Access Compliance Report

Public Rights-of-Way

(Curb Ramps)

Intersection ID: 7969	Main Street: BROOKSHIRE BV	Cross Street: N_HOSKINS_RD	Location: SW
ADA ID: 8BF63CA0951D	Ramp Type: Para	Initial Pass/Fail: Pass	Overall Compliance: No
			Severity Score: 25.25

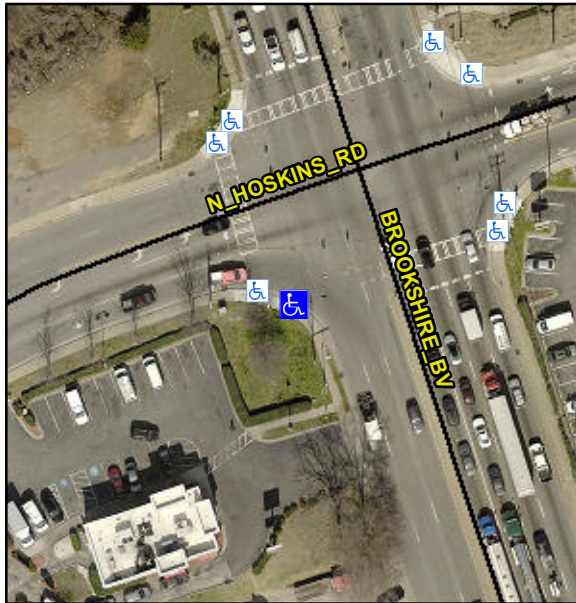
LT RP < 5%

**R304.5.3, R304.2.1, R304.2.2-Perp,
R304.3.2-Para, R305, R304.5.4**

Compliance	Description	Data	Compliance	Description	Data
N/A	Ramp Length LT (in)	64.0	N/A	Ramp Length RT (in)	69.0
Yes	Ramp Width LT (in)	70.5	Yes	Ramp Width RT (in)	70.5
Yes	Ramp Slope LT (%)	3.0	Yes	Ramp Slope RT (%)	7.5
No	Ramp XSlope LT (%)	2.7	No	Ramp XSlope RT (%)	2.6
No	Landing Length (in)	N/A	No	DWS Provided?	No
No	Landing Width (in)	N/A	N/A	DWS Contrast?	No
No	Landing Slope (%)	N/A	N/A	DWS Length (in)	N/A
No	Landing X Slope (%)	N/A	N/A	DWS Full Width?	No
N/A	Landing Curb? (Y/N)	No	N/A	DWS Offset (in)	N/A
N/A	Shared Landing?	No			
Yes	Gutter Ponding?	No	No	Gutter Slope (%)	5.2
Yes	Gutter Lip Ht (in)	0.0	Yes	Gutter X Slope (%)	1.1
N/A	Painted X Walk1?	Yes	N/A	Painted X Walk2?	N/A
	X Walk 1 Direction	To NE		X Walk 2 Direction	N/A
N/A	X Walk 1 Width (in)	77.0	N/A	X Walk 2 Width (in)	N/A
	X Walk 1 Slope (%)	1.0		X Walk 2 Slope (%)	N/A
	X Walk 1 X Slope (%)	2.1		X Walk 2 X Slope (%)	N/A
Yes	Ramp inside XWalk1?	Yes	N/A	Ramp inside XWalk2?	N/A

**Remove & Replace Entire Ramp.
Remove & Replace Gutter.**
